CHG TO: 80 149				
THIRD ANGLE PROJECTION				
DRAWN C.W. GOWDY	DATE 02SEP09	SIZE 15.00	STROKE ALL	TYPE HOS
NAME OF PART OUTLINE - 15.00 VVCP CYLINDER				
CHECKED B. BENNITT	DATE 18SEP09	SIZE C	FEDERAL SUPPLY CODE	DWG NO. HIHO1551
APPROVED B. BENNITT	DATE 18SEP09	WT.	REV. 01	
SCALE 1:12				
SHEET 1 OF 1

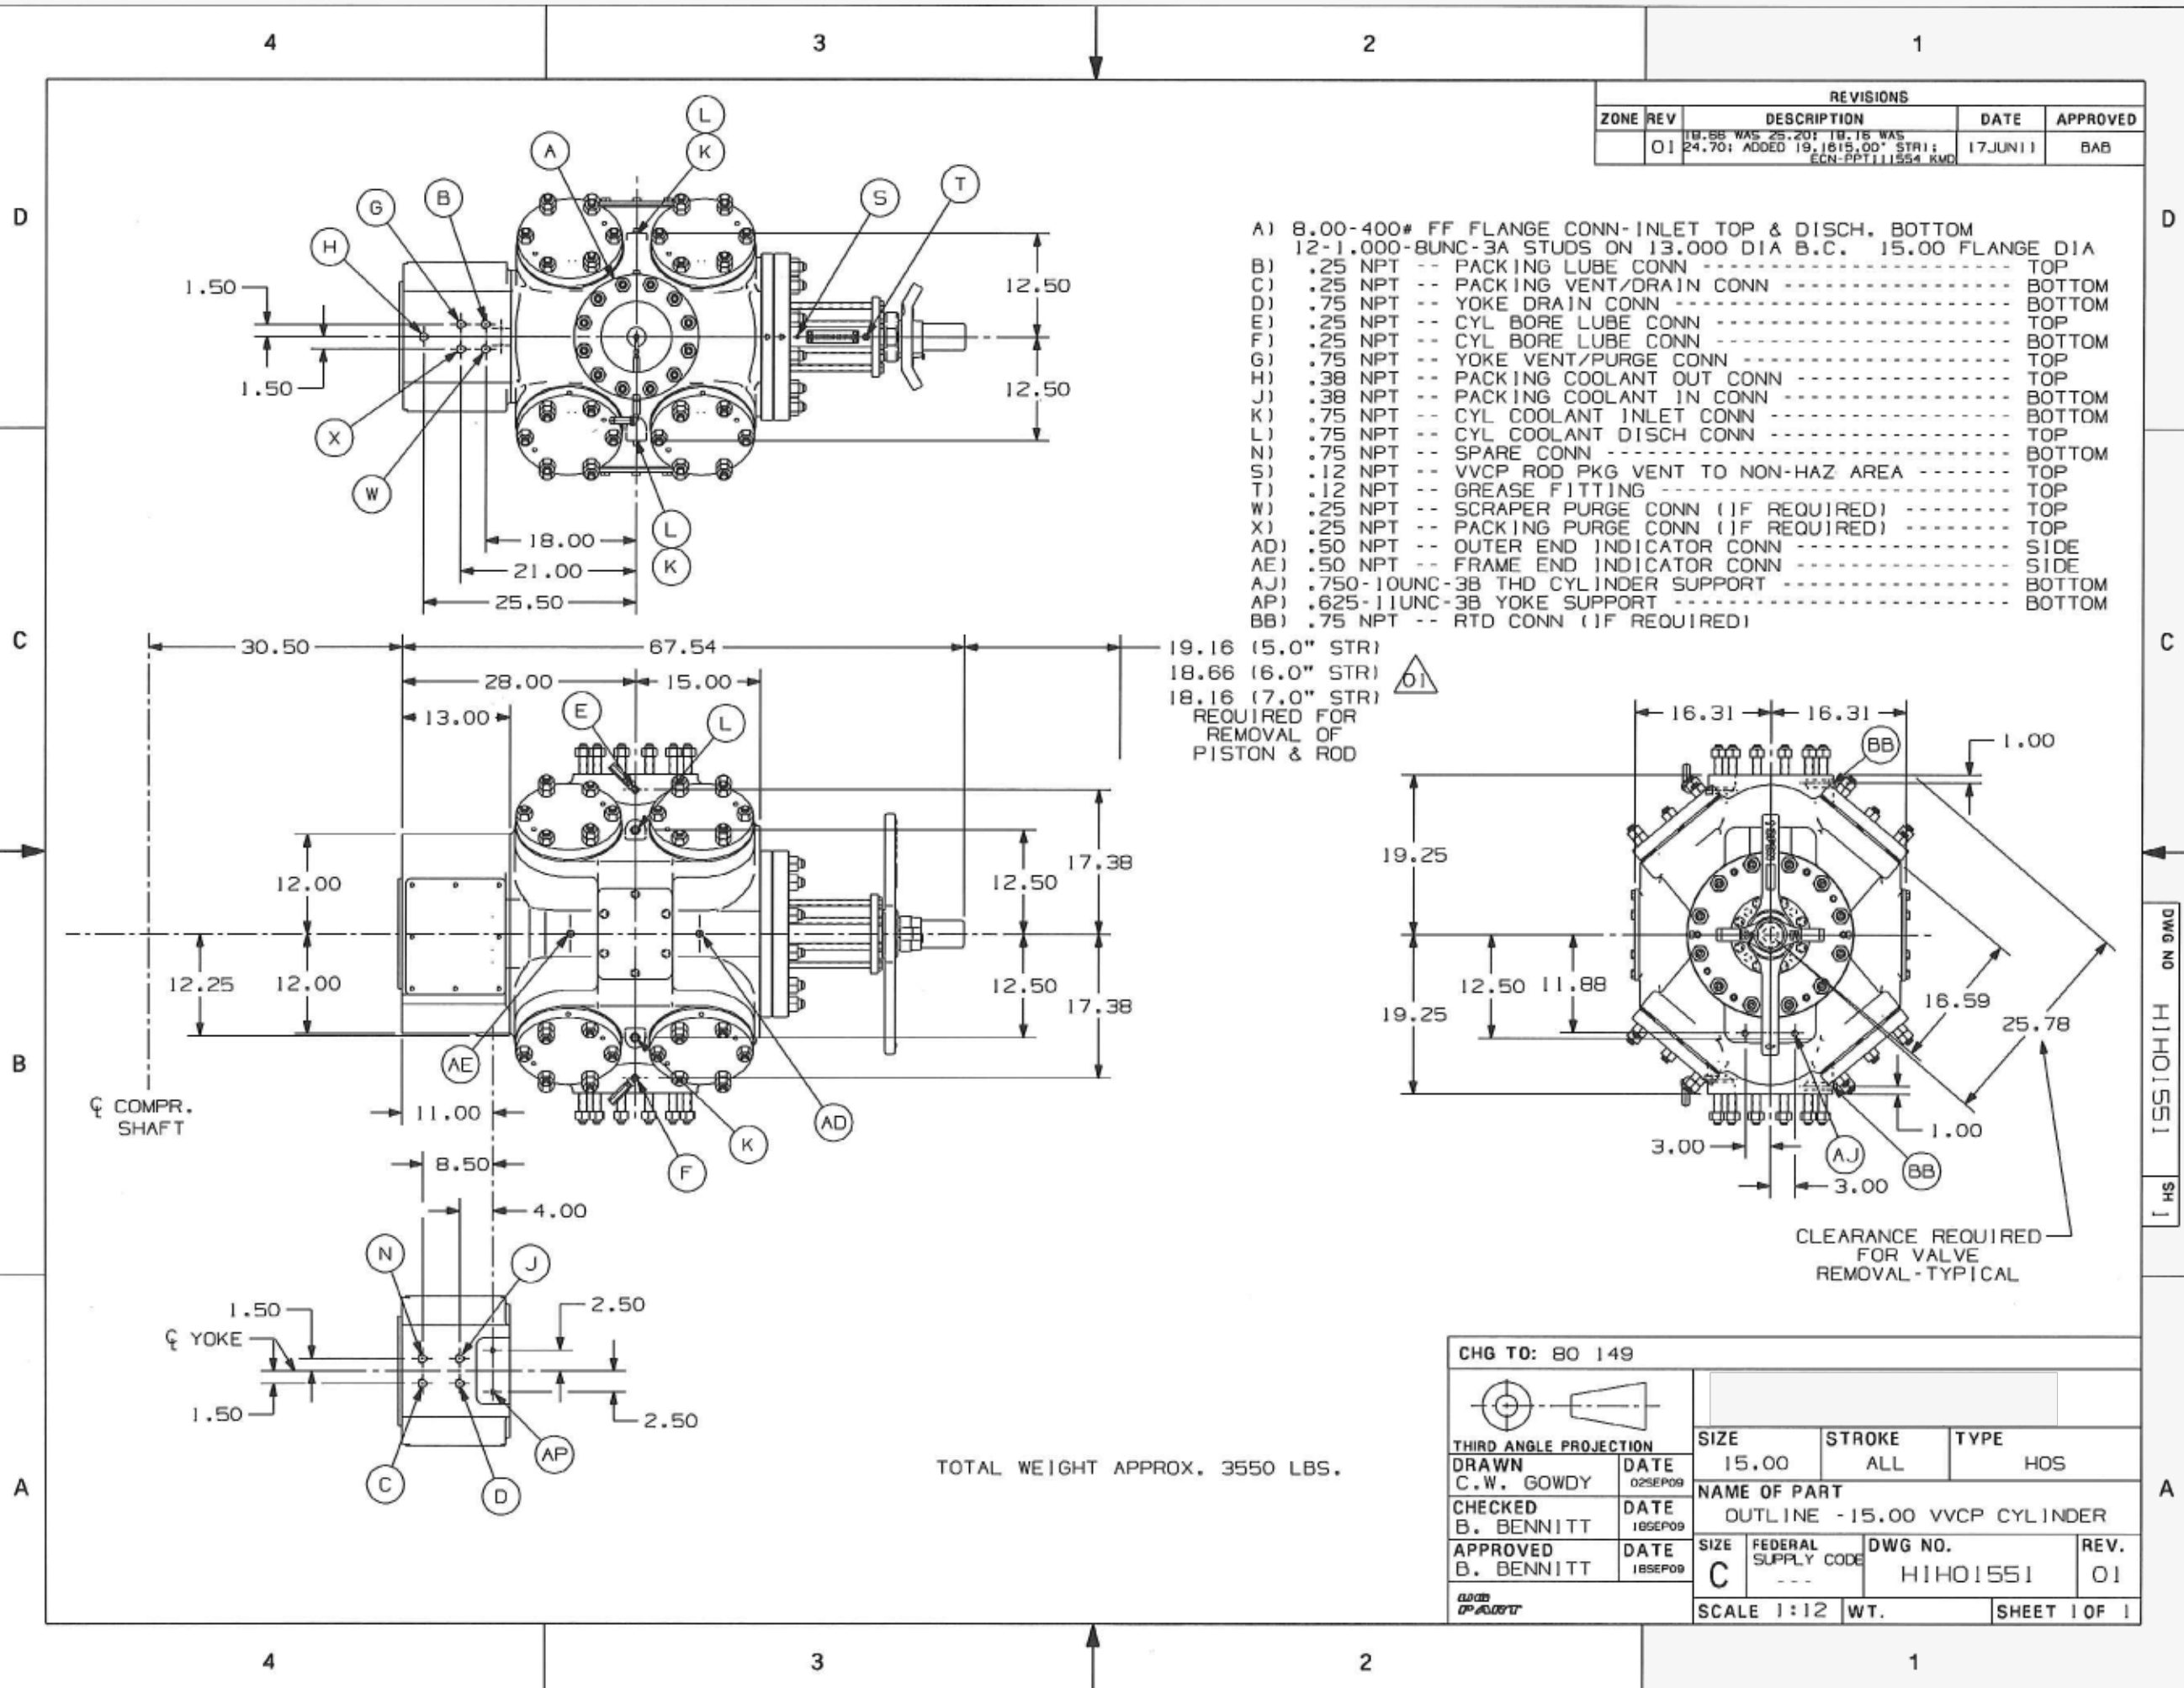
REVISIONS				
ZONE	REV	DESCRIPTION	DATE	APPROVED
	01	18.66 WAS 25.20; 18.16 WAS 24.70; ADDED 19.16; 15.00" STR; ECN-PPT111554 KMD	17JUN11	BAB

19.16 (5.0" STR)
18.66 (6.0" STR)
18.16 (7.0" STR)
REQUIRED FOR
REMOVAL OF
PISTON & ROD
